Lot 44 Whispering Woods  
1620 SW 27<sup>th</sup> St  
Lee's Summit, MO

**COMPLIANCE LETTER**

This letter shall serve as verification that Apex Engineers, Inc. ("Apex") has reviewed the following requested deviations from the Permit Plan drawings and found the following changes to be acceptable.

Image 1: Plan change locations

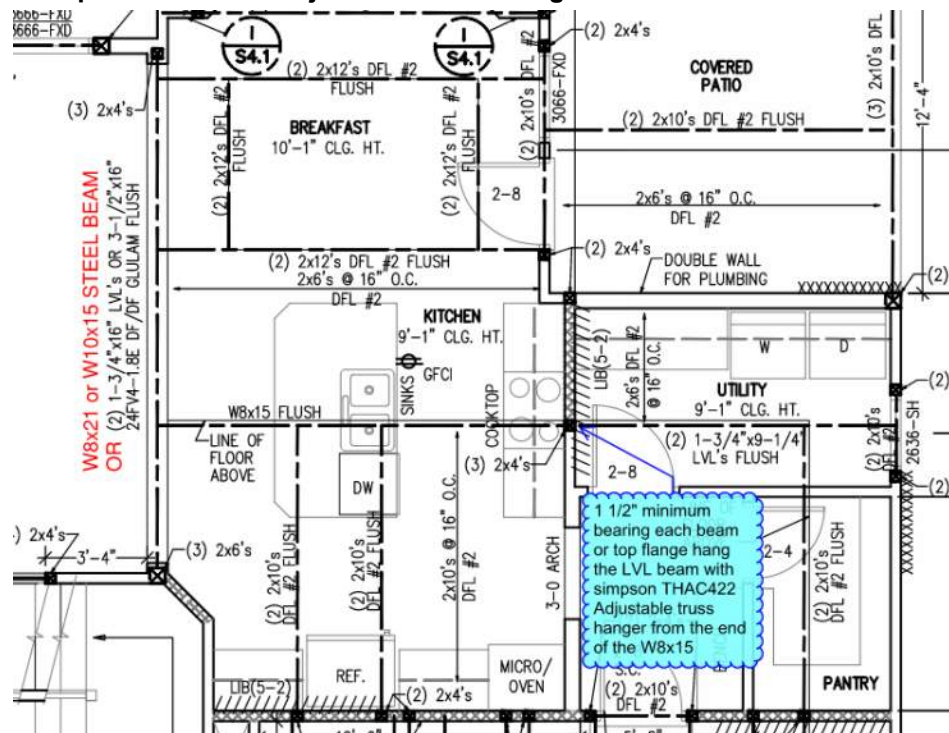
1. Flush beam between the kitchen and 2 story gathering room on First Floor Plan.
  - **After review, the 16" LVL or glulam beam may be replaced by either a flush W8x21 or upset W10x15 steel beam.**
2. Bearing of flush W8x15 steel beam and (2) 1-3/4"x9 1/4" on 2x4 top plate.
  - **After review, both the steel and LVL beam shall bear a minimum of 1 1/2" on the 2x4 top plate in the wall. Alternatively, the LVL beam may be hung with a Simpson THAC422 Adjustable Truss Hanger.**
